TOWN OF COLCHESTER
APPLICATION FOR
FINAL PLAT REVIEW

- 5) PROJECT STREET ADDRESS: 242 Severance Road
- 6) TAX MAP & PARCEL #(can be obtained at Assessor's Office) Tax Map 4, Parcels 30-1, 30-2, 30-3, 30-5, 30-6, 30-7, 30-8, 30-9, 30-10, 30-11, 30-12, 30-13

- 7) PROJECT DESCRIPTION
 - a) Please note if new lots are being created and whether or not the request is for a regular subdivision, planned residential development, or planned unit development: _____
This application is for a planned unit Development that will create new lots.

IRELAND INDUSTRIES SUNDERLAND FARMS COMMUNITY

HYDRANT PLAN

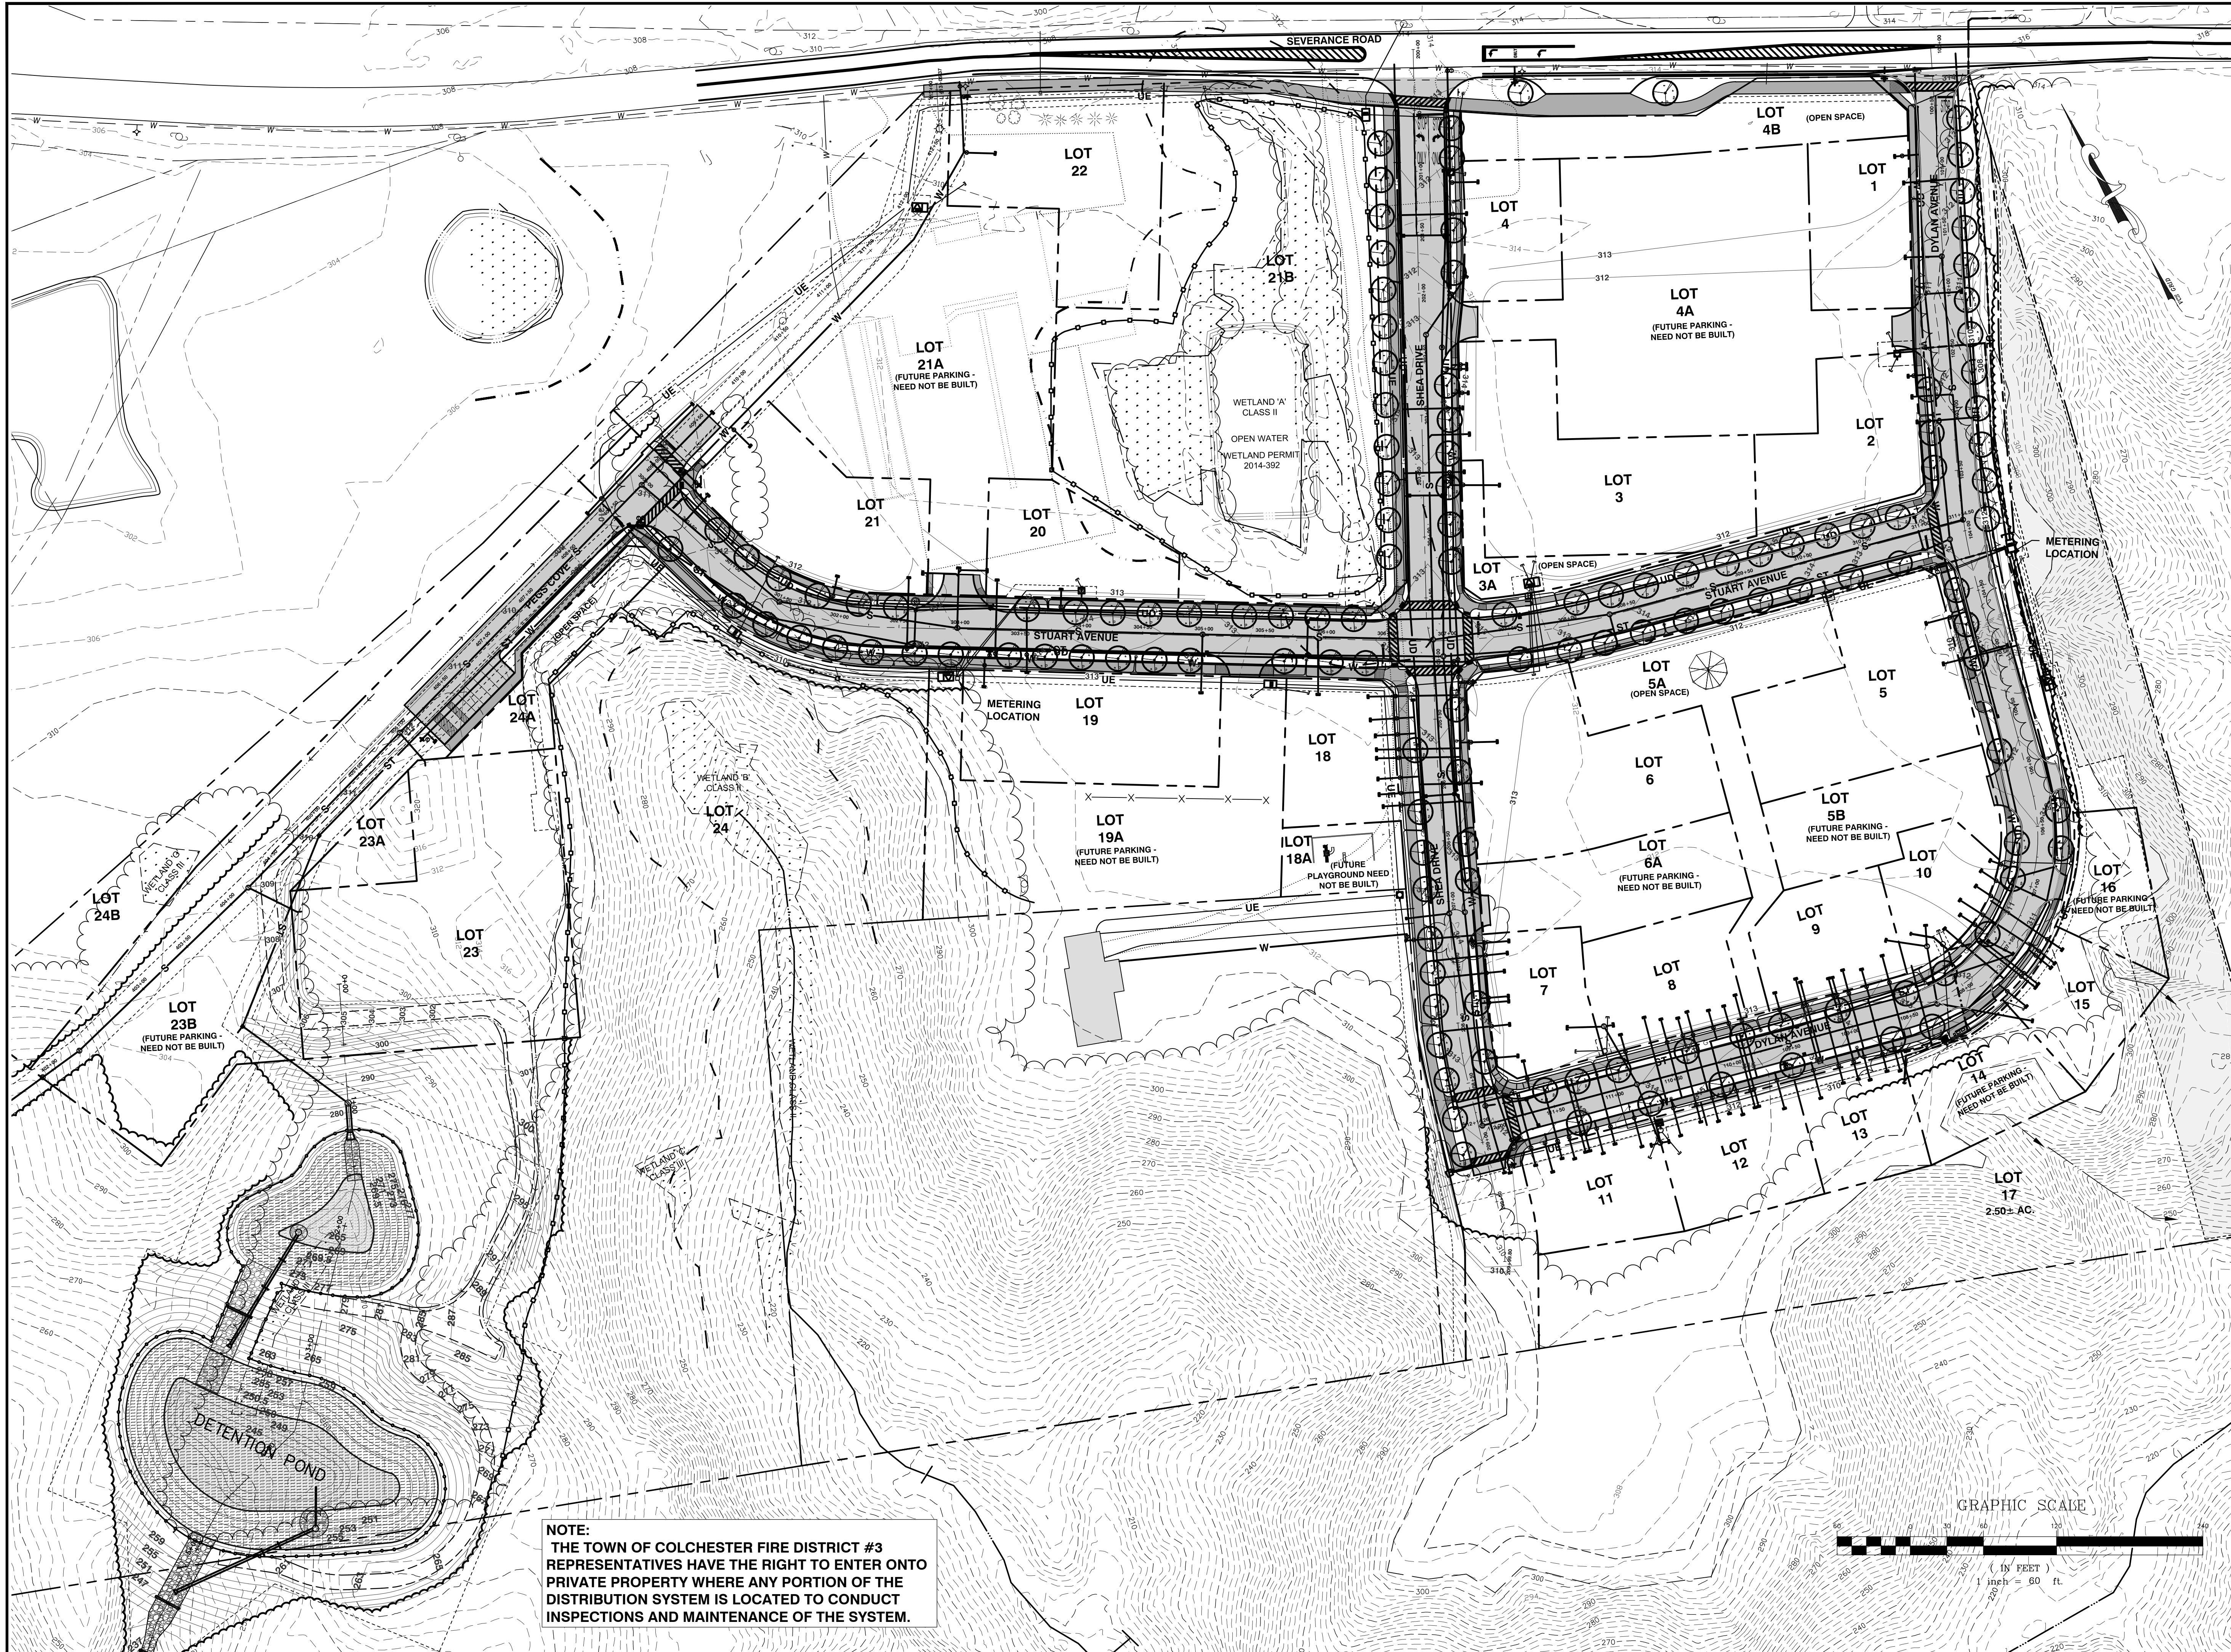
6. All utilities shall be underground. **Acknowledged as that is what is proposed.**
7. All hydrants shall have a 4” stortz. **This noted has been added to the hydrant detail on Sheet C5.-Water Details**

OVERALL UTILITY
PLAN

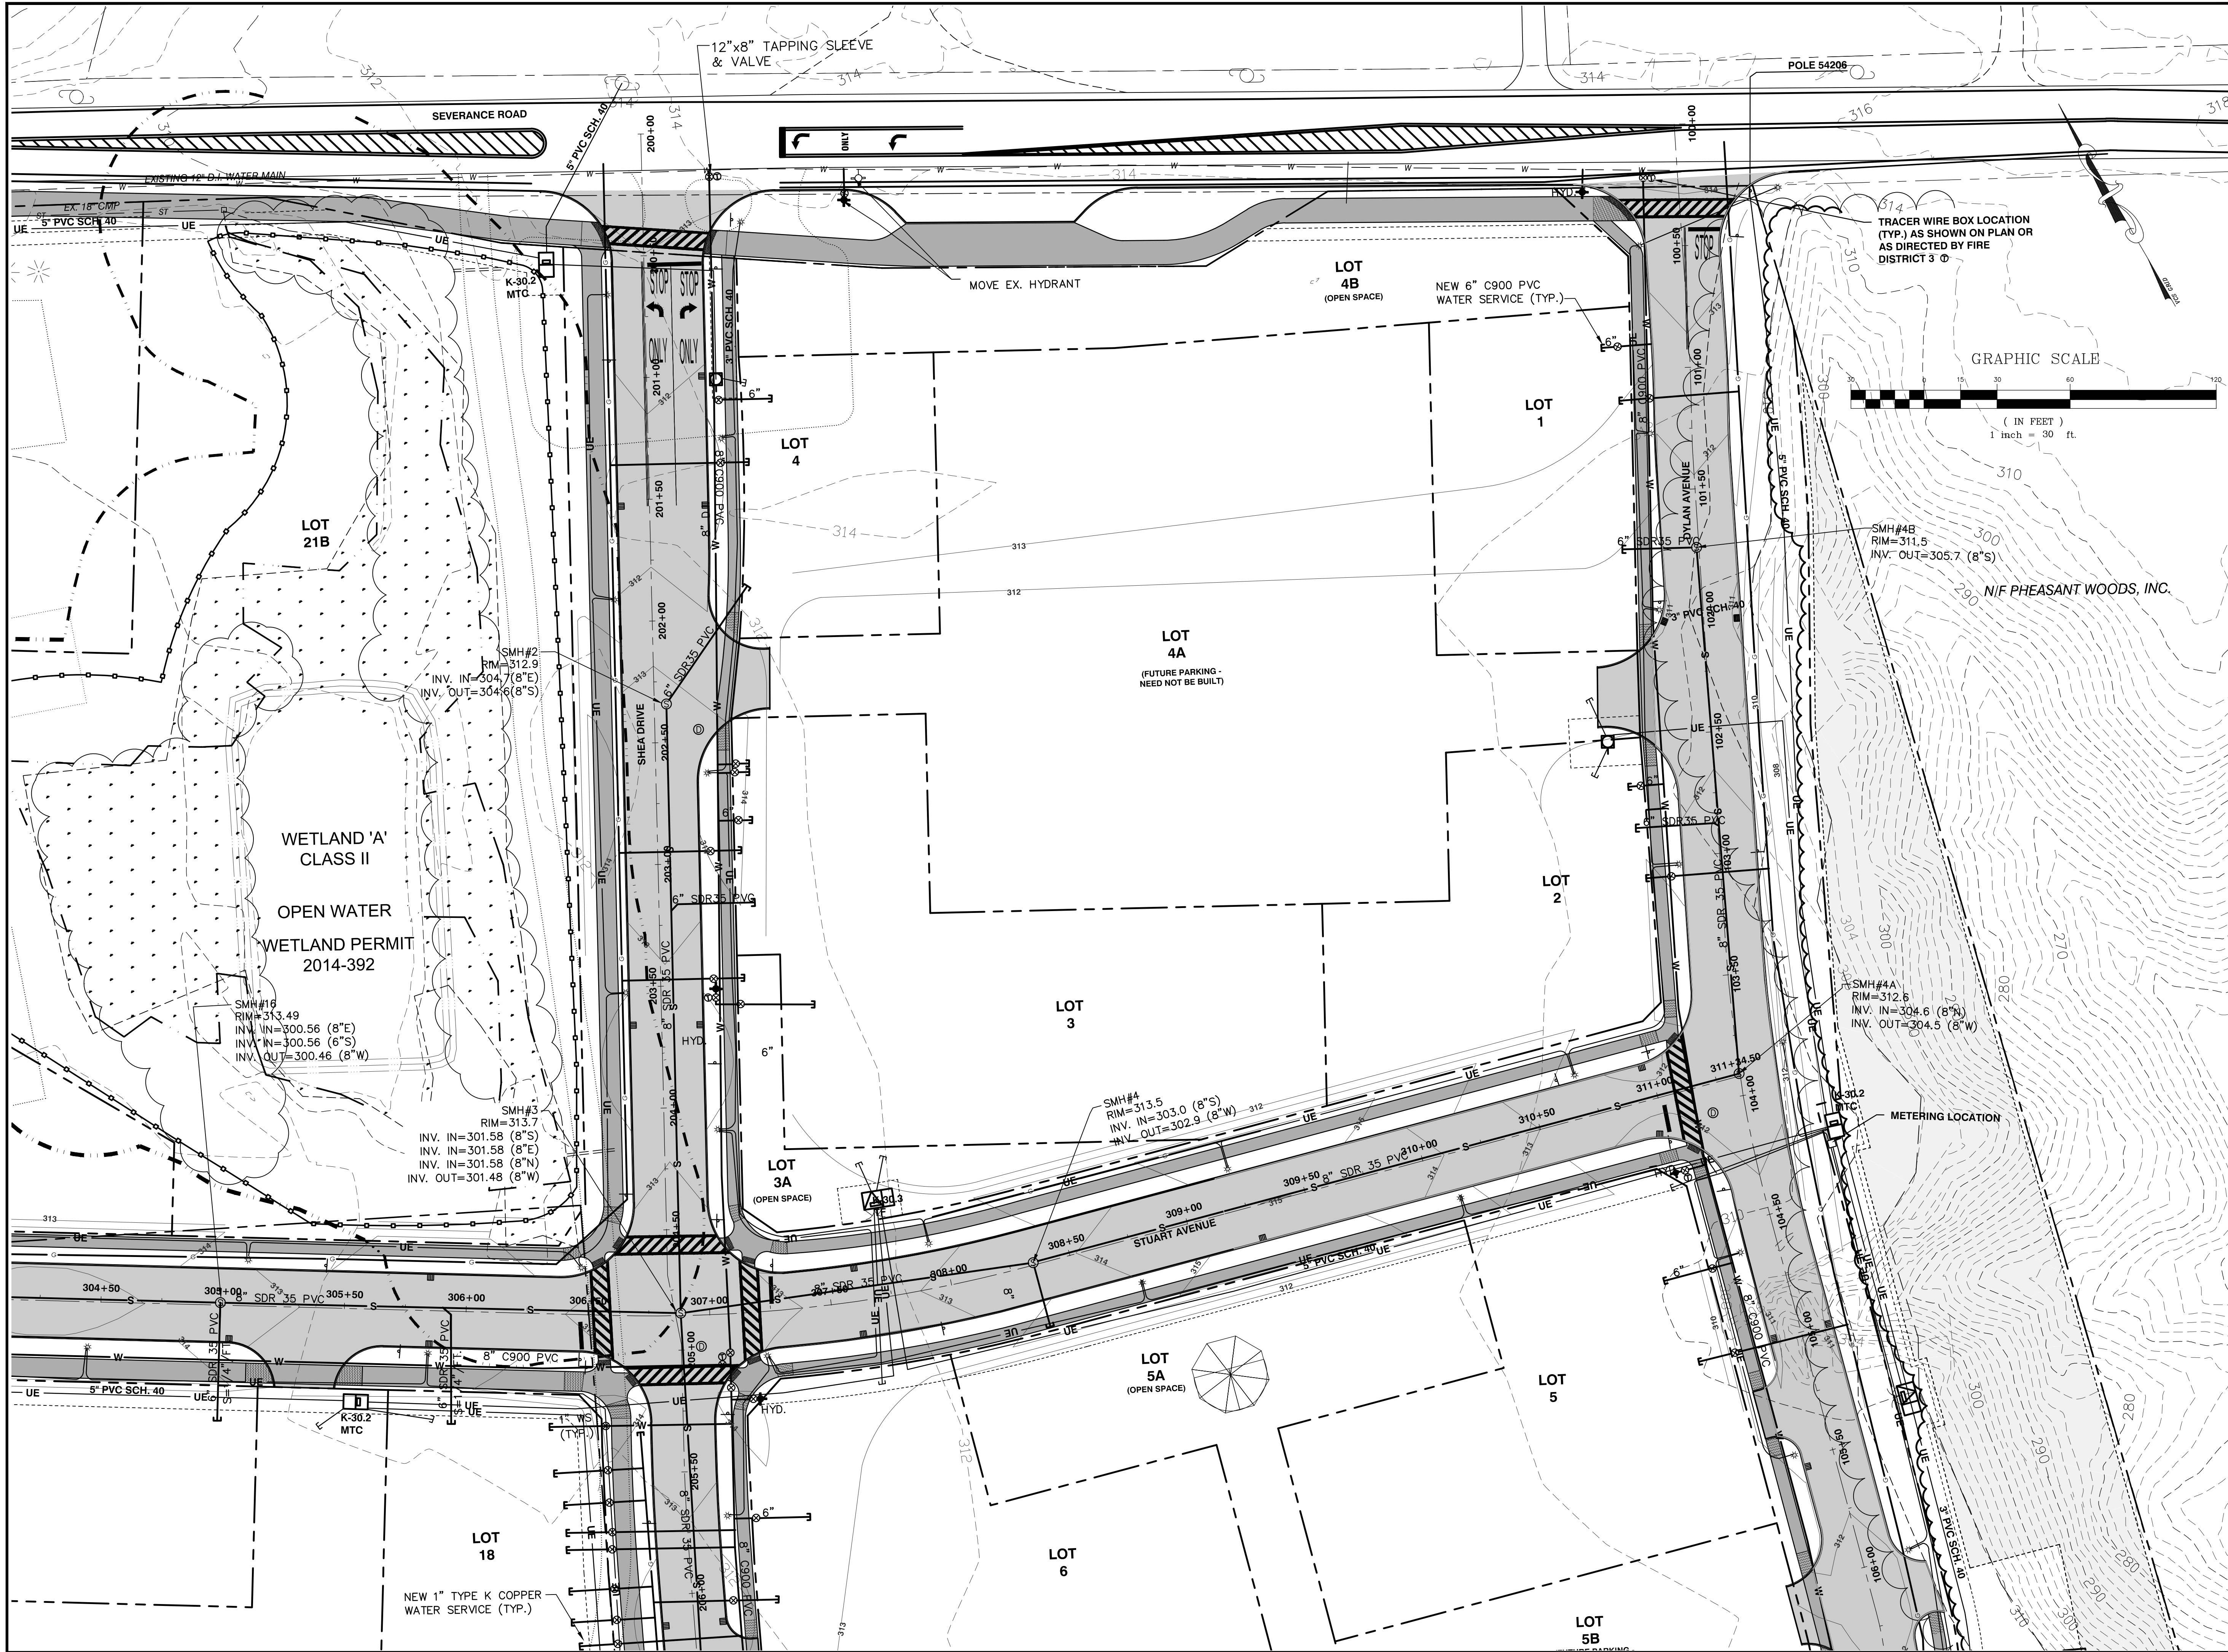
7. Per item #17, are there easement requirements to allow CFD#3, or its designee, to enter this project to inspect and/or maintain the distribution system following construction? **We have added a Note on Sheet C3.0 indicating that Colchester Fire District #3 representatives have the right to enter onto private property where any portion of the distribution system is located to conduct inspections and maintenance of the system.**
